Seggimoor Farmyard
 Bishop Norton Road, Glentham, LN8 2EU
 Huntsman Homes
 Drawing 020/0087
 13/10/20

PROPOSED PLANS
 1:100 AT 100% A2

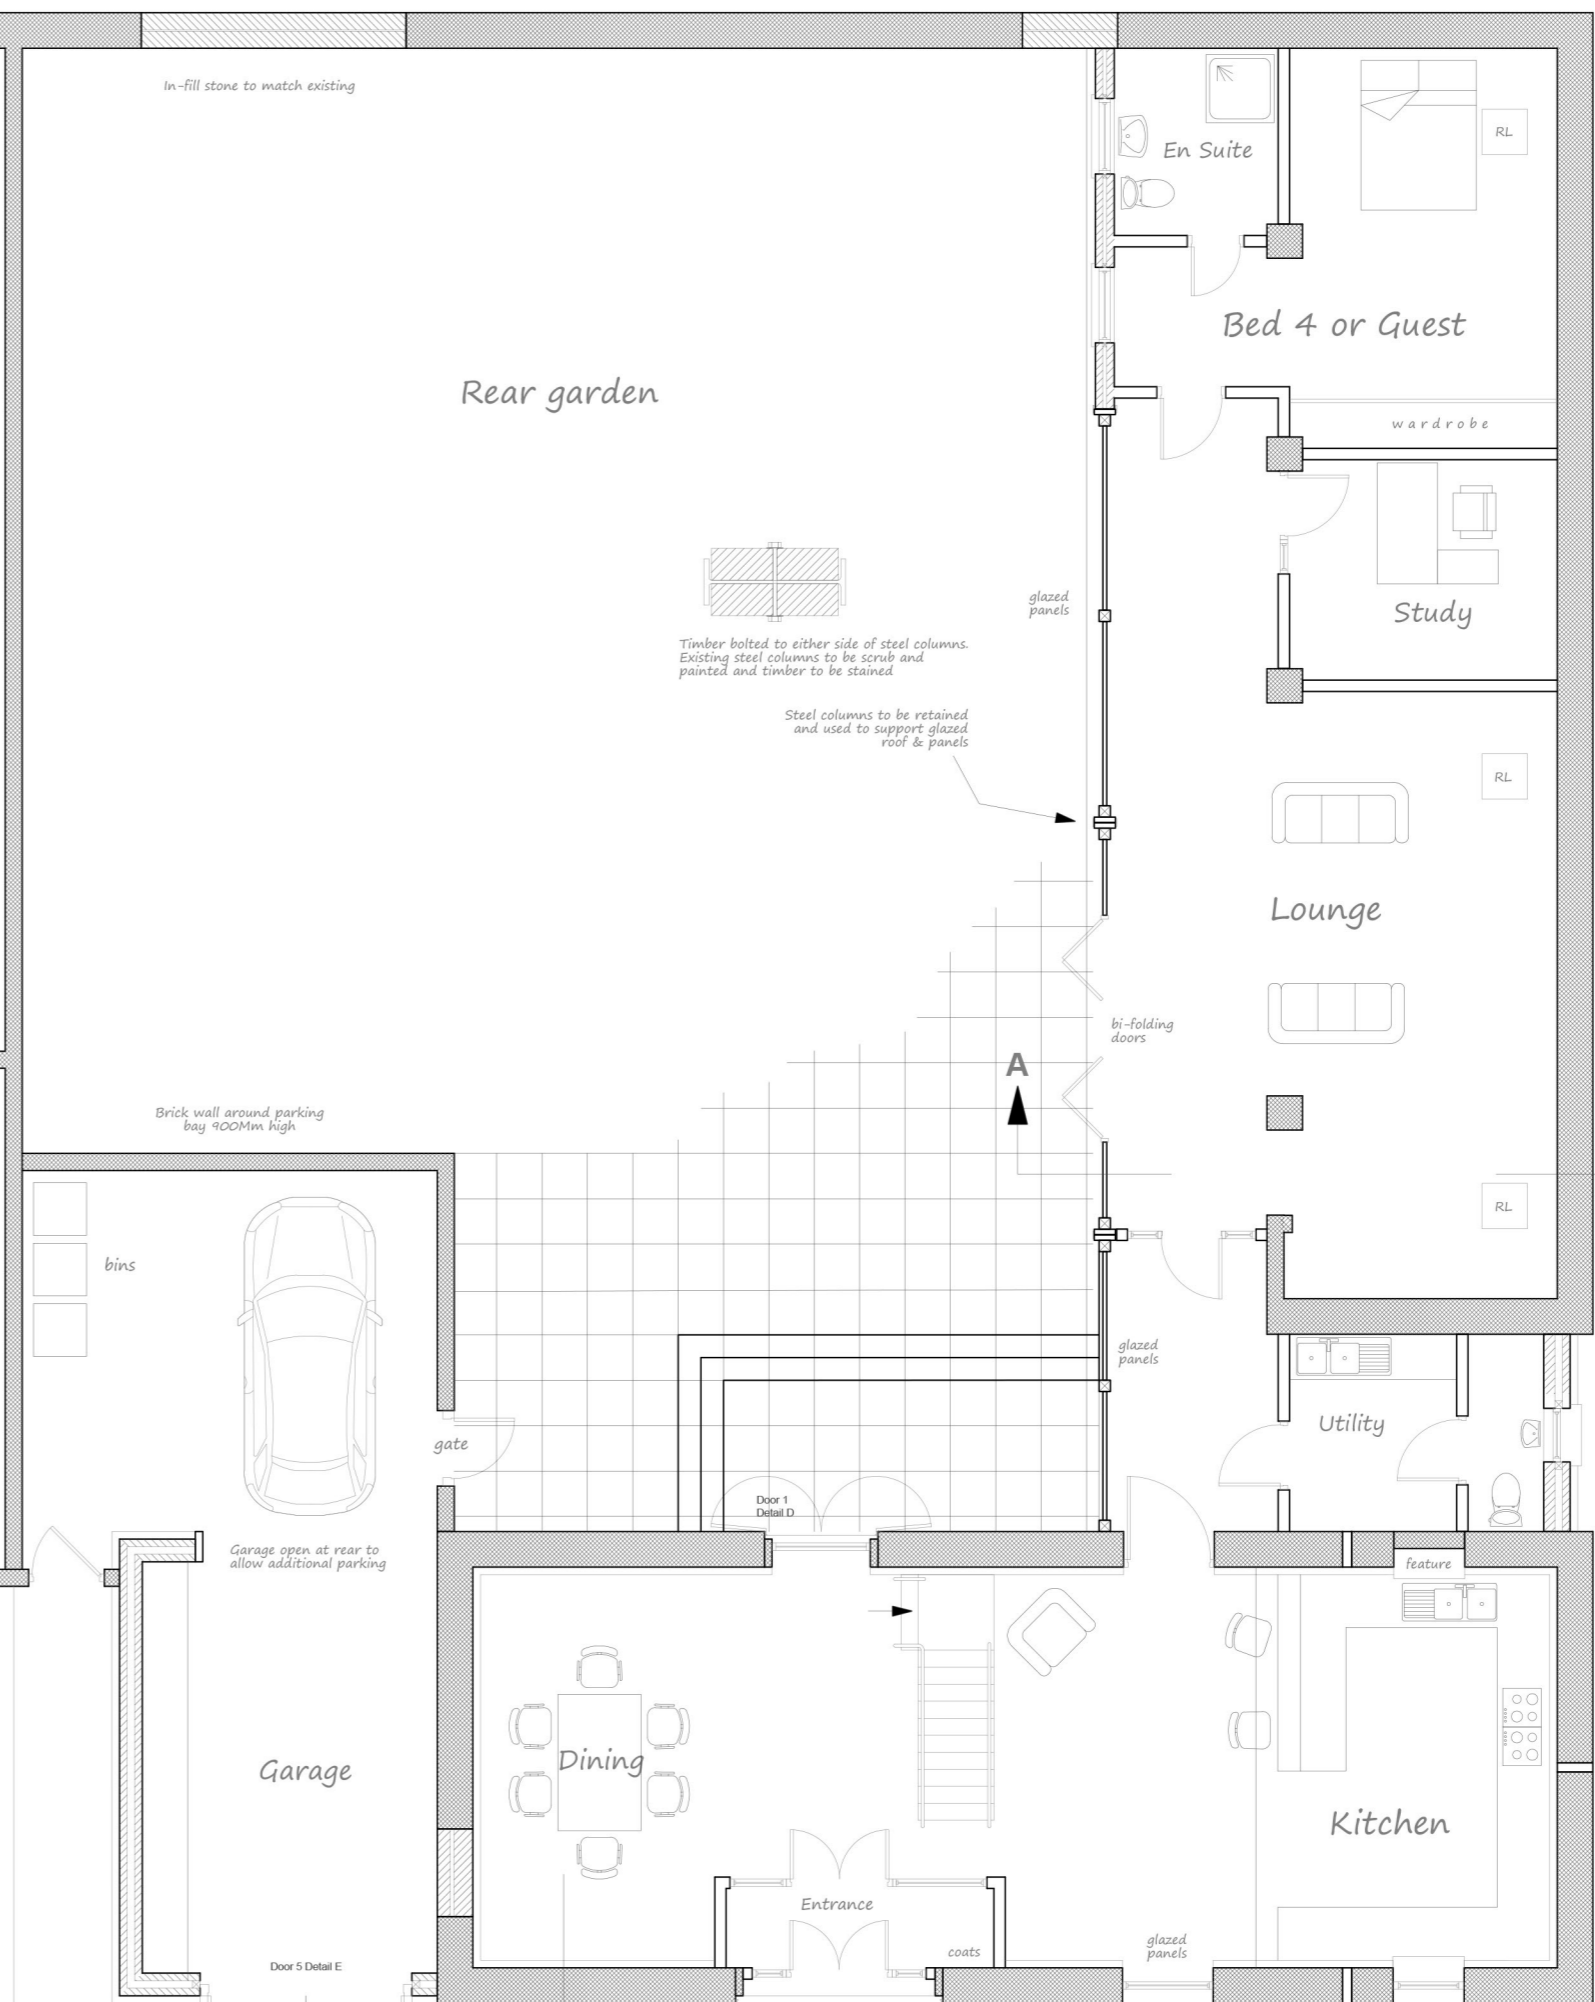
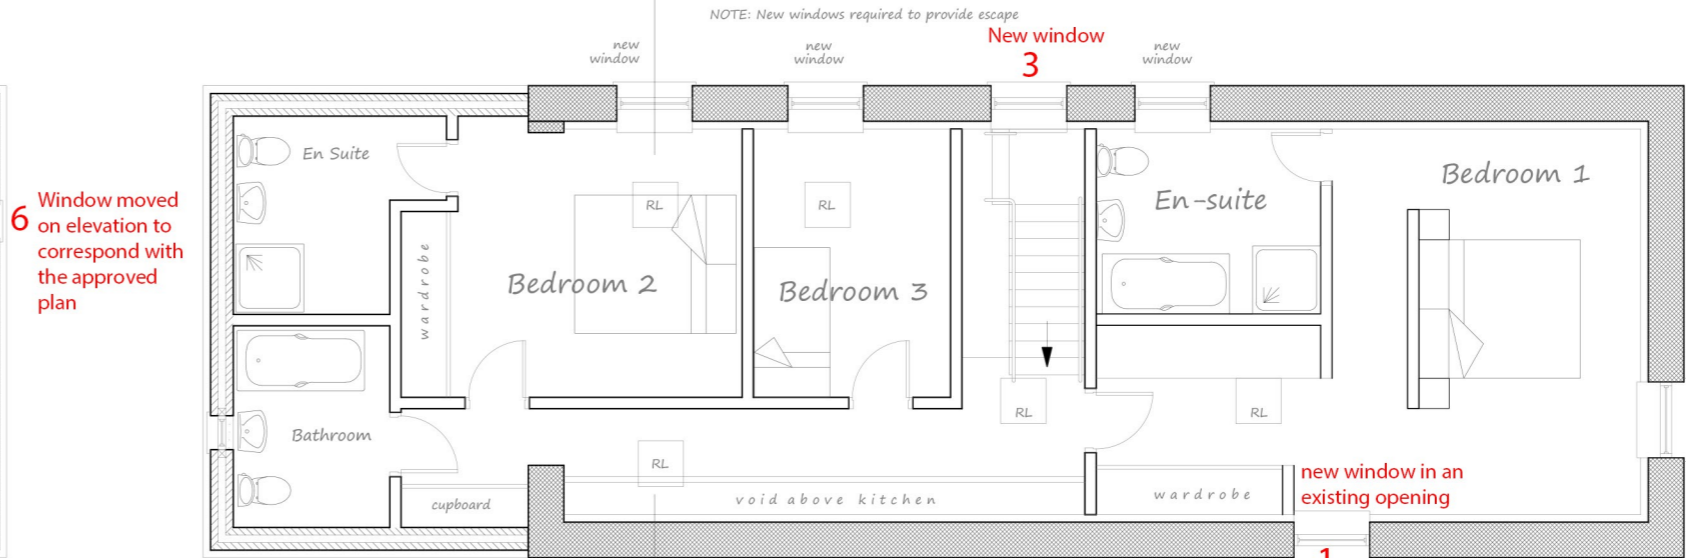
Window added to elevation to correspond with approved plan

Window moved on elevation to correspond with the approved plan

NOTE: New windows required to provide escape
 1 new window
 2 New window
 3 New window
 4 New window
 5 new window
 6 Window moved on elevation to correspond with the approved plan
 Position and size of existing window opening to be confirmed
